General Electric Company  
175 Clinton Avenue, Schenectady, NY 12305

MFN No. 010-92  
Docket No. STN 50-605  
EEN-9206

Subject: GE Response to Agenda Items 1,5,9 and 16 Discussed During the  
GE/NRC Reactor Systems Branch Meeting on November 20-21,  
1991

Figure 1. ABWR Stability

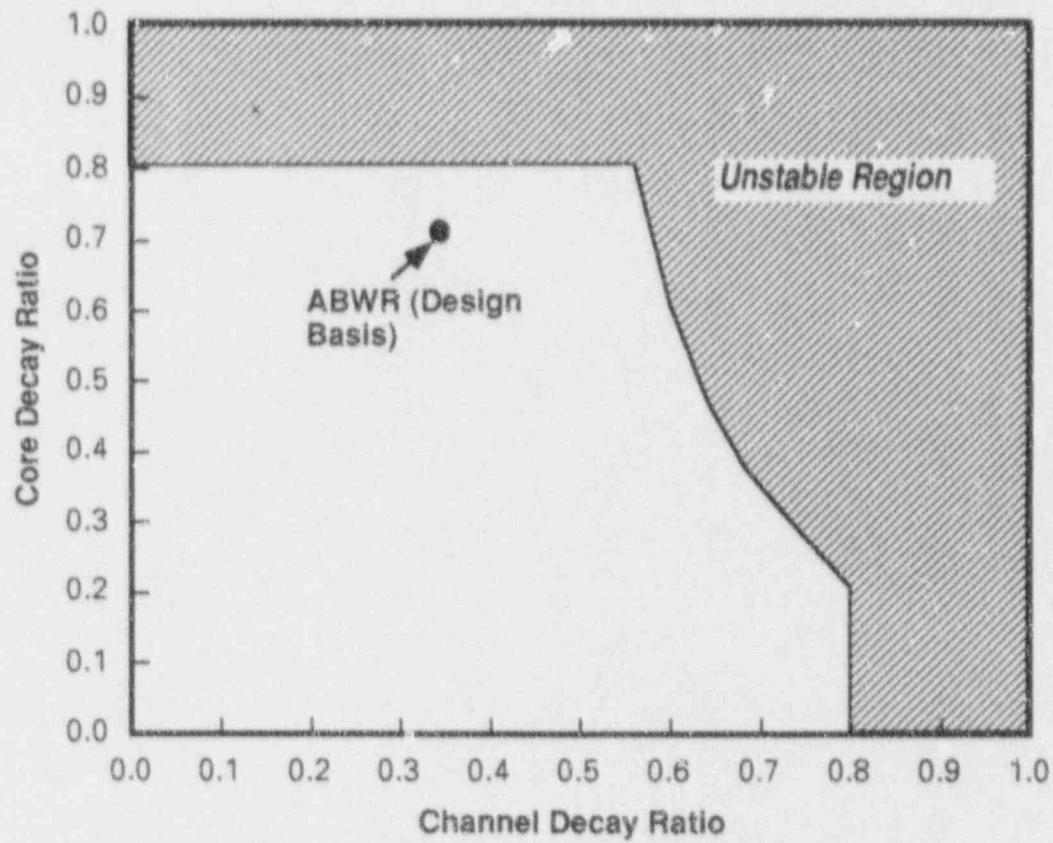
In order to reconfirm this conclusion, a stability analysis based on the procedures developed by the BWROG committee on thermal hydraulic stability (Reference 1) was performed for the ABWR. In this analysis, conservative nuclear conditions, taking into consideration of future core design, were assumed. The results at the most limiting conditions in the normal operating region (i.e.; the intercept of 102 % rod line with all operating RIPS at their minimum speeds, assuming only 9 out of 10 RIPS are in operation) are as follows:

-	Core Decay Ratio	0.72,
-	Channel Decay ratio	0.36.

These results are also shown in Figure 1 together with the criteria. From Figure 1, it is confirmed that that ABWR is stable in the normal operating region.

Figure 2. Stability Controls and Protection Logic

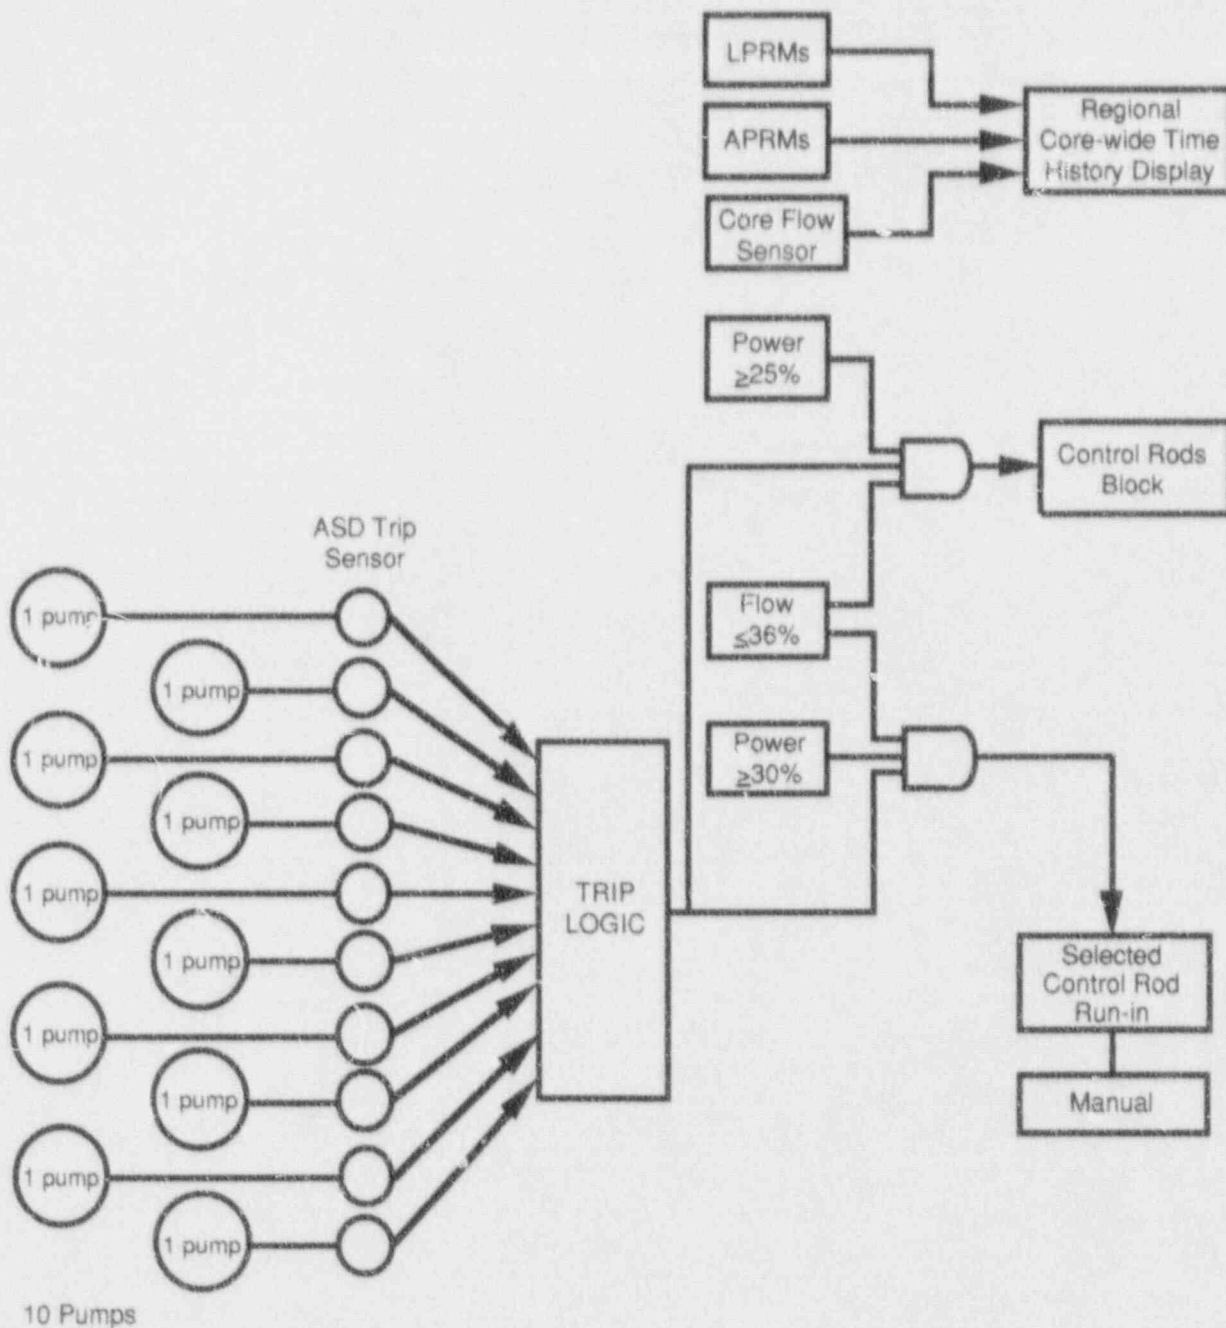
Furthermore, automatic logics (Figure 2) which prevent plant operation in the region with the least stability margin are also implemented. This design is similar to Option I-A, one of long-term solutions considered by the BWROG. In addition, in order to meet the stability design requirements specified in the ALWR Utility Requirements Document, Option III, LPRM based Oscillation Power Range Monitor (OPRM), which is also one of long-term solutions considered by the BWROG, will be implemented in the ABWR design, when the OPRM design is approved by the NRC.

Figure 10.1-1 REFERENCE STEAM & POWER CONVERSION SYSTEM

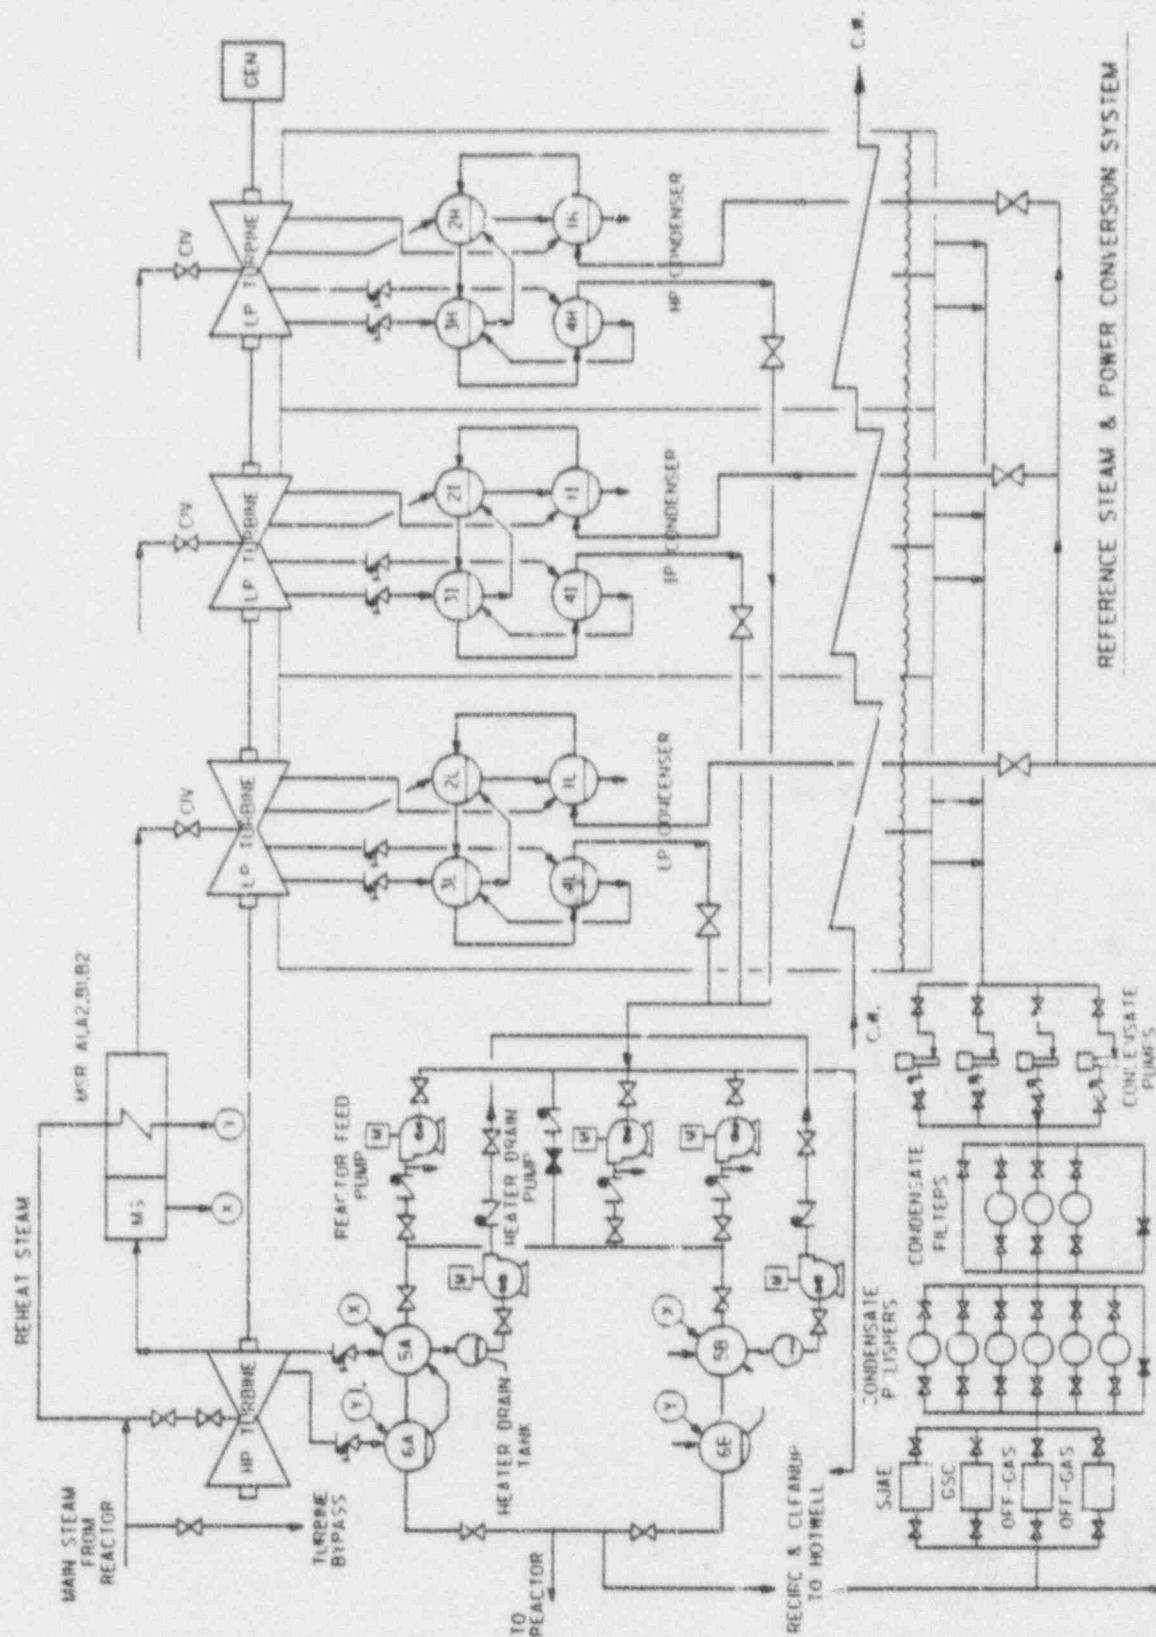
For ABWR design, the following design requirement is specified for the FW heating system design :

"No single operator error or equipment failure shall cause loss of more than 55 °C (100 °F) feedwater heating ."

The reference steam and power conversion system shown in Figures 10.1-1 to 10.1-3 meets this requirement. In fact, the FW temperature drop based on the reference heat balance shown in Figure 10.1-2 is as follows:

- isolation of one low pressure heater < 15 °F
- isolation of one high pressure heater < 28 °F
- isolation of one low pressure heater string < 53 °F
- isolation of one high pressure heater string < 53 °F

Therefore, the use of 100 °F temperature drop in the transient analysis is conservative.
